TECHNICAL BULLETIN

Rover 75, Rover 75 Tourer diesel

Nº: TB0090 Issue 1

MAF SENSOR CONTAMINATION - WATER SHEDDER

5

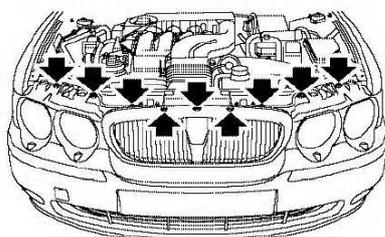
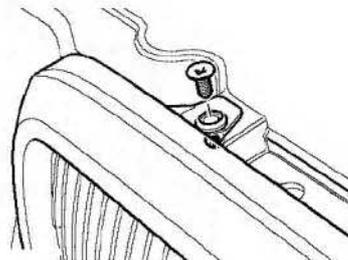
1. *Rover 75 (Saloon & Tourer)*: Remove the 9 upper screws securing the front bumper to the bonnet locking platform (illustration 5). Remove the 2 scrivenets securing the front grille to bumper and remove grille (illustration 6).

7

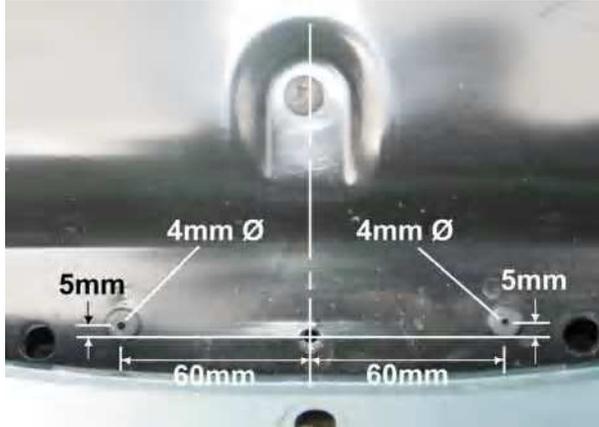
2. With the front bumper pulled and held forward (Rover models only), make 2 marks on the bonnet locking platform where the water shedder fixing holes are to be drilled. Referring to illustration 7, measure 60mm to the left and 60mm to the right of the centre line then 5mm back from the bumper fixing holes as indicated, mark where lines cross.

NOTE: The illustration shows a later stage with pop rivets fitted.

8

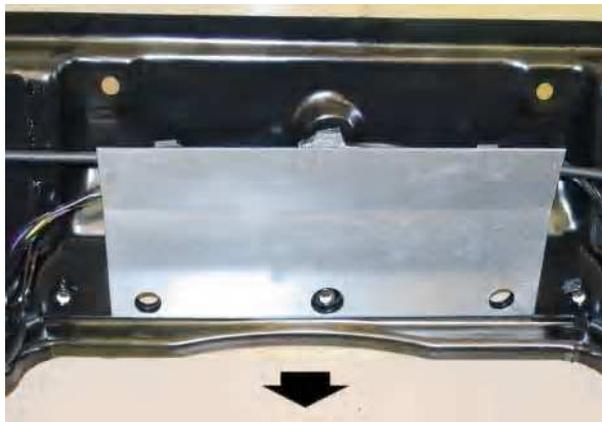
3. Drill 2 X 4mm Ø holes in the bonnet locking where marked.
4. Touch in bare metal where drilling took place with anti-corrosion primer.
5. Referring to illustration 8, position water shedder (part number PHL000010) under the bonnet locking platform with its 3 large holes facing the front of the vehicle and the deflector section facing the engine and pointing down (the arrow in illustration indicates front of vehicle).

NOTE: The plate has been designed to locate below the existing platform wiring and clips. The large central hole in the shedder locates around the bumper fixing weld nut on the underside of platform.

6. With water shedder held in position by hand, mark through the drilled holes in the bonnet locking platform.
7. Remove shedder and drill 2 X 4mm holes where positions were marked.
8. Re-position the shedder and hold in position against the underside of the bonnet locking platform. Ensuring that wiring is not trapped, rivet the shedder in position using 2 X 4mm pop rivets.
9. Refit grille (Rover models) or bumper (MG models).
